Monticello Extended Power Uprate: Response to NRC Electrical Engineering Review Branch (EEEEB) Request for Additional Information (RAI) dated March 28, 2009, (TAC No. MD9990)

NSPM RESPONSE TO EEEB RAIs DATED MARCH 28, 2009

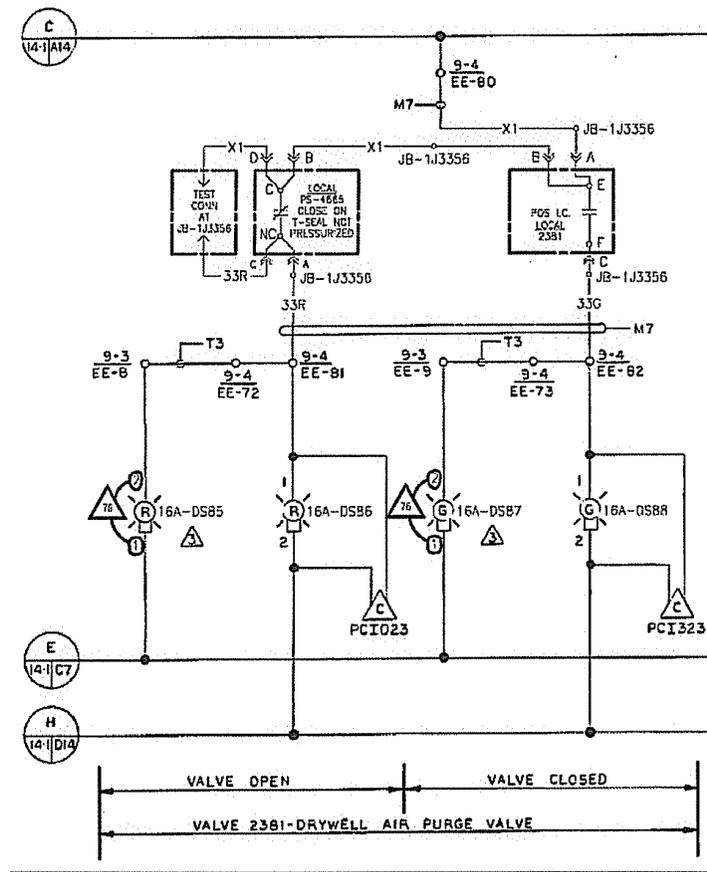
In Note 4 of Section 3.4.3, the licensee stated that the Rockbestos cables could be submerged and these cables are qualified for 18 hours in a submerged condition. The staff requests the licensee to provide the basis for the 18 hour criteria for qualification, and also confirm that these cables are not submerged more than 18 hours and that these cables will perform their safety function during and post submergence.

The Rockbestos cables used in this application are not submerged more than 1 hour and will perform their safety function during and post submergence.

The event for which the predicted worst-case 1.7 foot submergence level in Reactor Building Volume 32 is based upon is the "RWCU-B-30-R0" case, all other HELB events affecting this location have less than 6-inches of submergence. The peak submergence level in Volume 32 is reached at 70 seconds, and the level reduces to 0-inches at 1861 seconds. The cables are therefore predicted to be submerged for less than 1 hour. The qualification of the cables is based on Rockbestos Reports QR-5804/5805. The 18-hour (minimum of QR-5804 testing) soak following the simulated LOCA testing was conducted at room temperature with tap water. The cable testing was compliant with IEEE Standard 383-1974 and included mandrel re-bending.

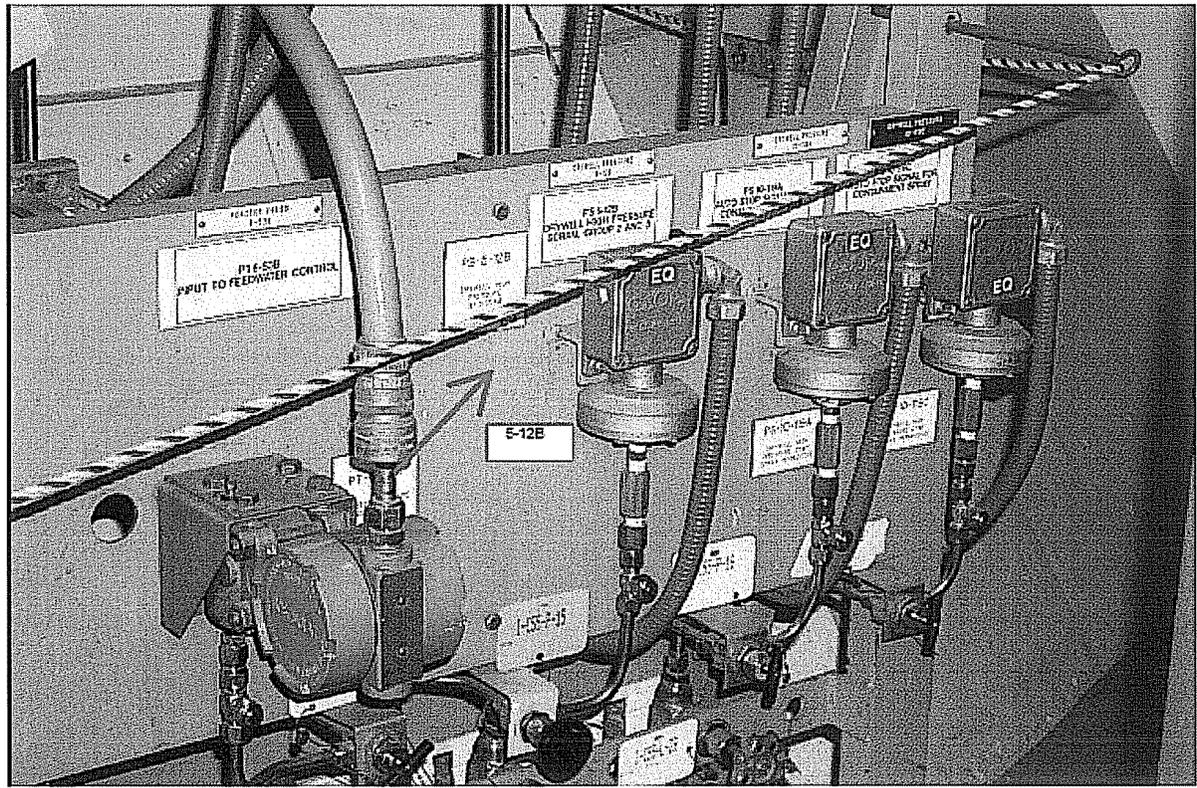
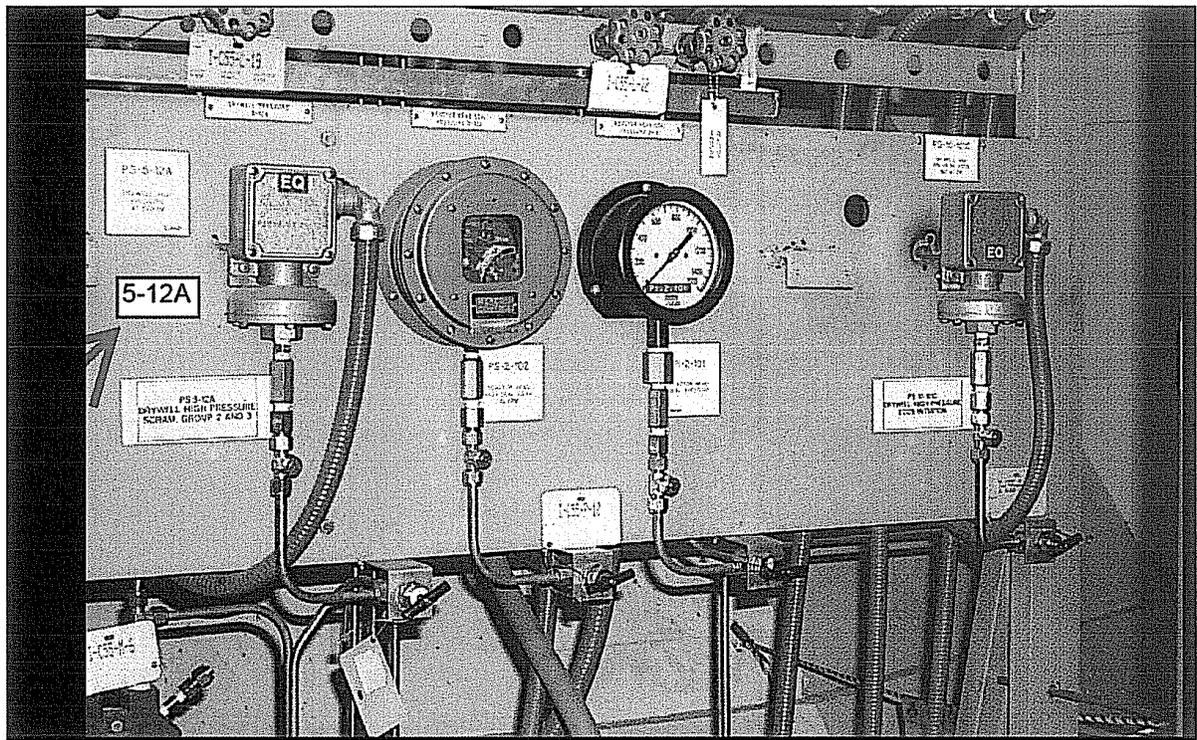
The licensee stated that additional testing from Barton on this switch model would easily demonstrate qualification for the temperature postulated under EPU conditions. The staff requests the licensee to confirm that this test is complete and that the switch is qualified for EPU conditions.

The additional testing referred to in Task Report 1004, Revision 1 is Barton Report R3-580A-9 which is complete and included as a reference source in the current EQ file. Although the results of this test indicated permanent set point shift in the specimen following the LOCA testing at greater than 340°F, the testing does indicate the survivability of the Model 580 pressure switch when subject to higher temperature conditions. The LPCI loop select pressure switches remain qualified under post-LOCA only operation at EPU power using the current Barton qualification test report R3-580A-29. The independent separate testing documented in Barton Report R3-580A-9 demonstrates that the switches would not severely degrade under the slightly higher temperatures (~210°F) predicted under EPU at the switch location.
